RE: C-67(231), Table Rock Northwest
Structure C006713510
Pawnee County Bridge Project

ADDENDUM NO. 1

This addendum adds Plan Quantities for two items on the Proposal Form. The added items are 1-34 (Rock Riprap, Type "B") and 1-35 (Riprap Filter Fabric). Please replace the affected sheet with the one attached hereto and noted by "Addendum No. 1" on the lower right corner of the page.

GENERAL NOTES, QUANTITIES, & INDEX

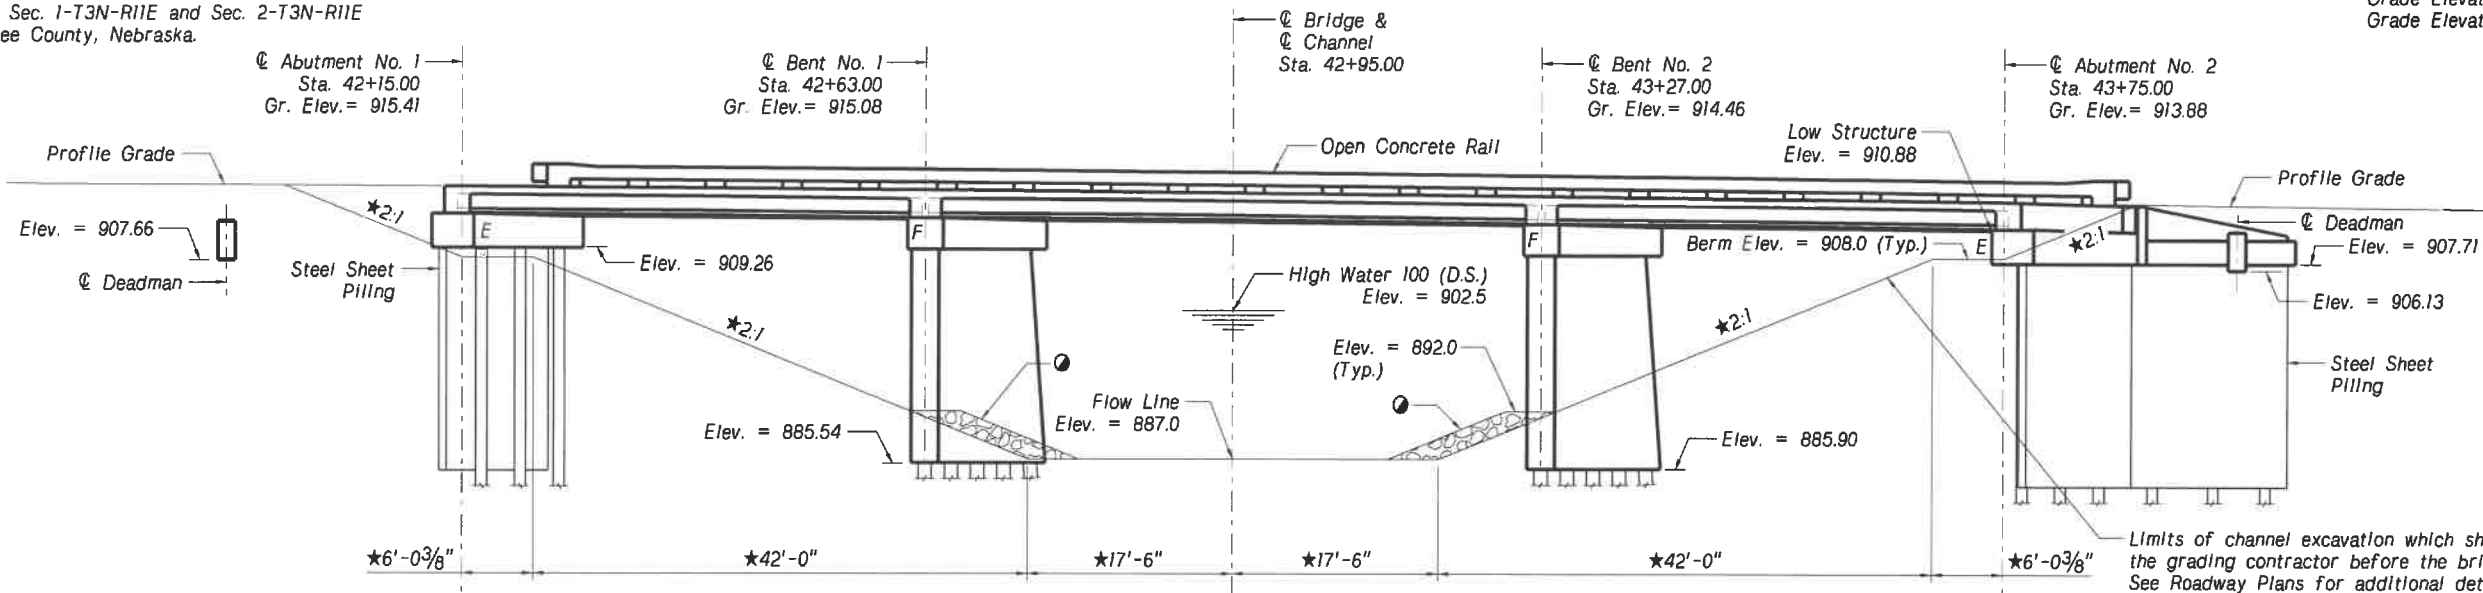
These items were also added to Plan sheets 6, 7 and 11 (sheets 1, 2 and 6 of 12 of the bridge plans). Please replace the affected sheets with those attached.

HP 12 in x 53 lbs PILE POINTS	_____	18	Each
ROCK RIPRAP, TYPE B	_____	98	Tons
RIPRAP FILTER FABRIC	_____	165	Sq. Yds.

SECTIONAL ELEVATION

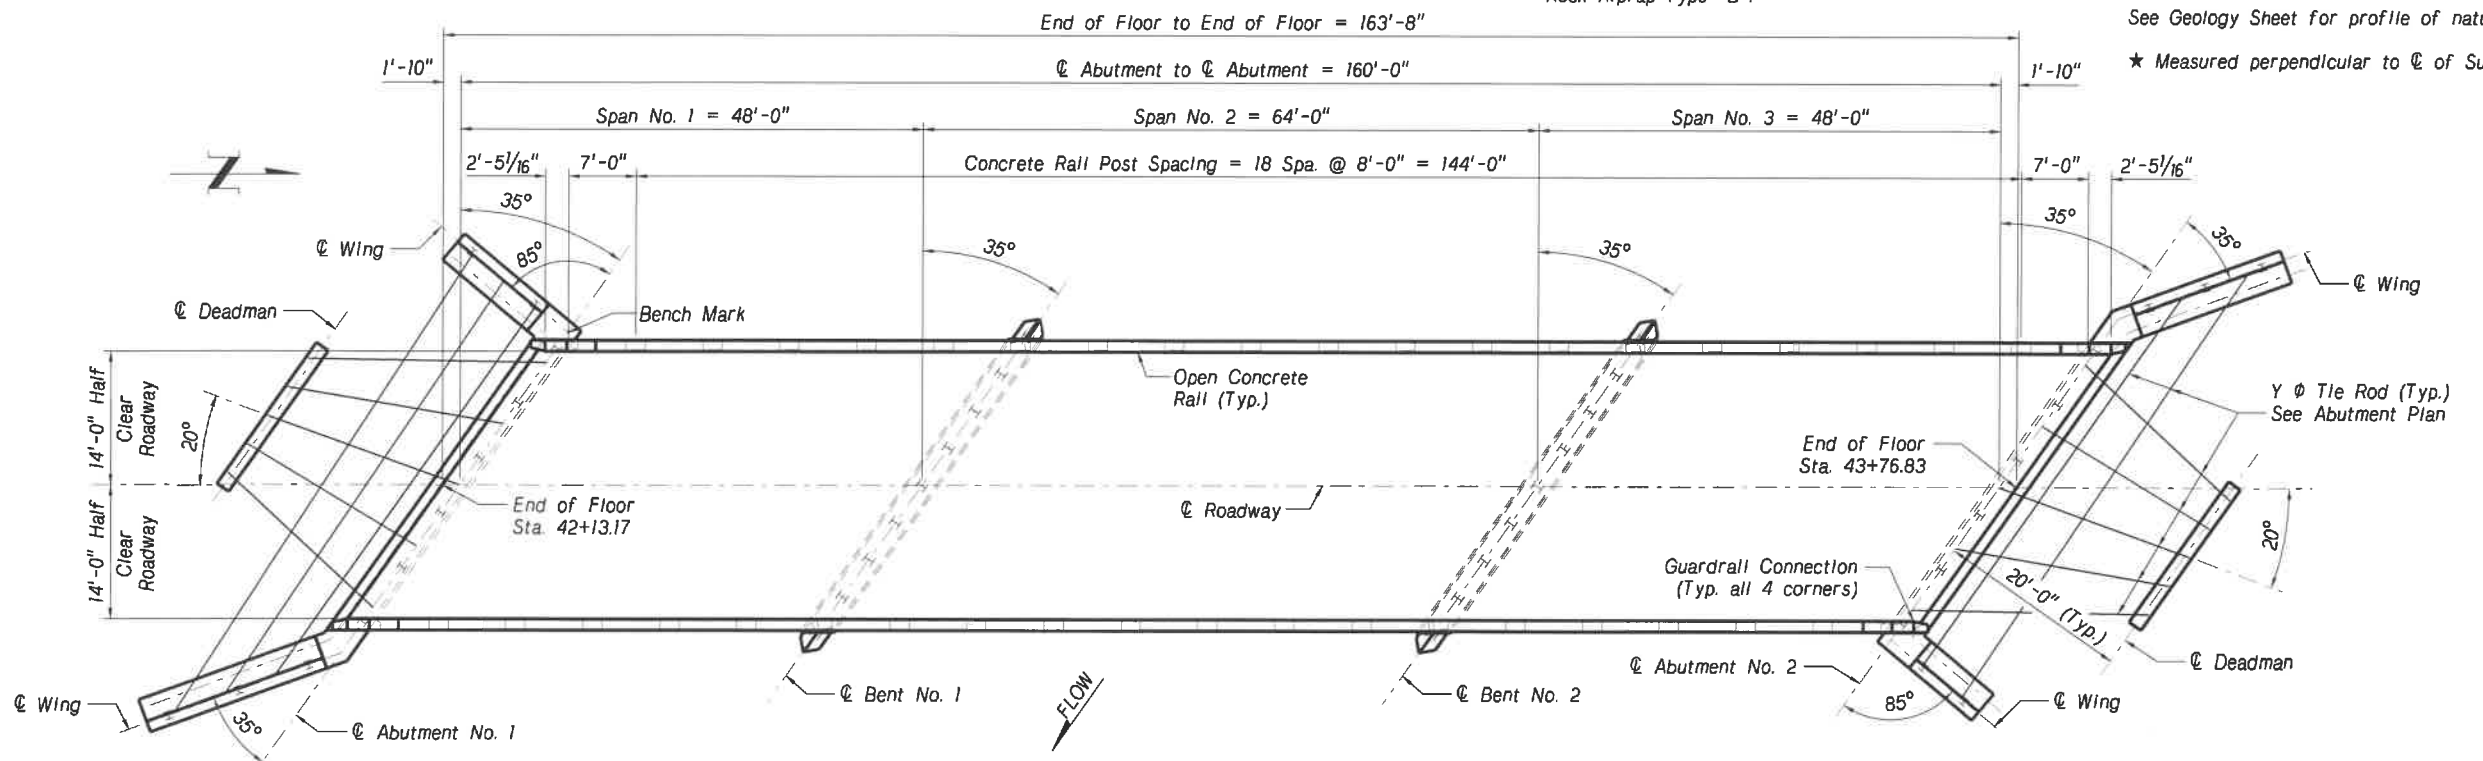
● Type "B" rock riprap, 2'-0" thick, placed on filter fabric. See Sheet 6 of 12 for Plan of Rock Riprap Type "B".

PLAN OF ROCK RIPRAP TYPE "B"

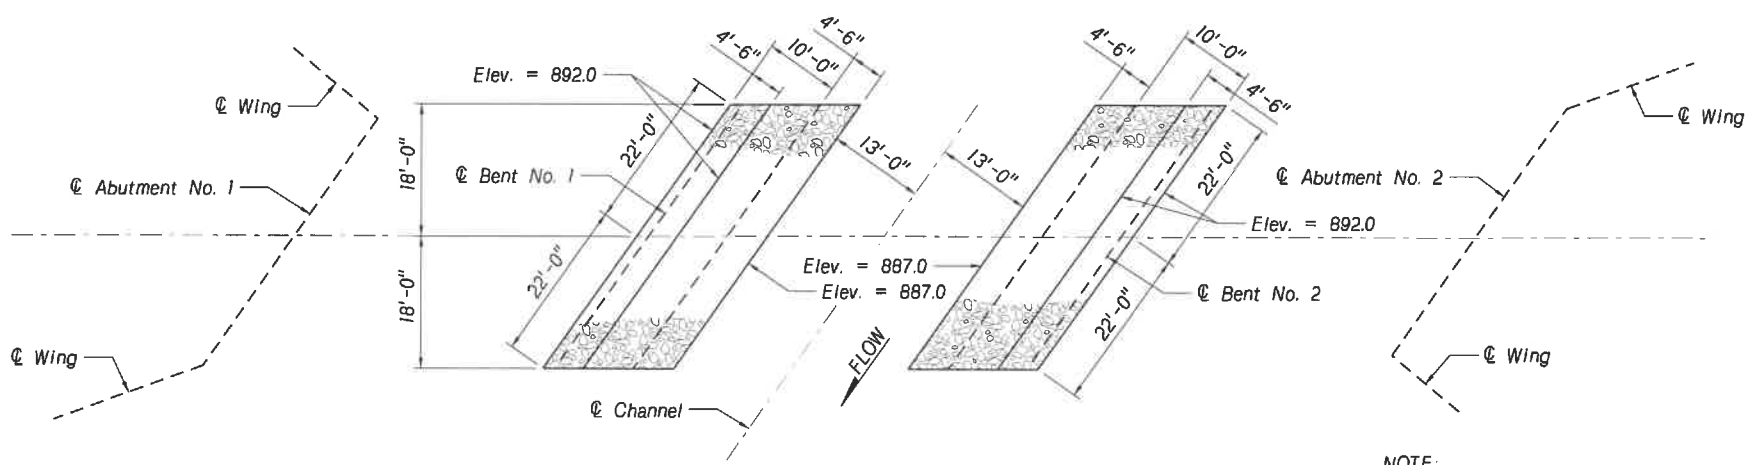
NOTE:
No deduction to Rock Riprap quantity for Bent areas.
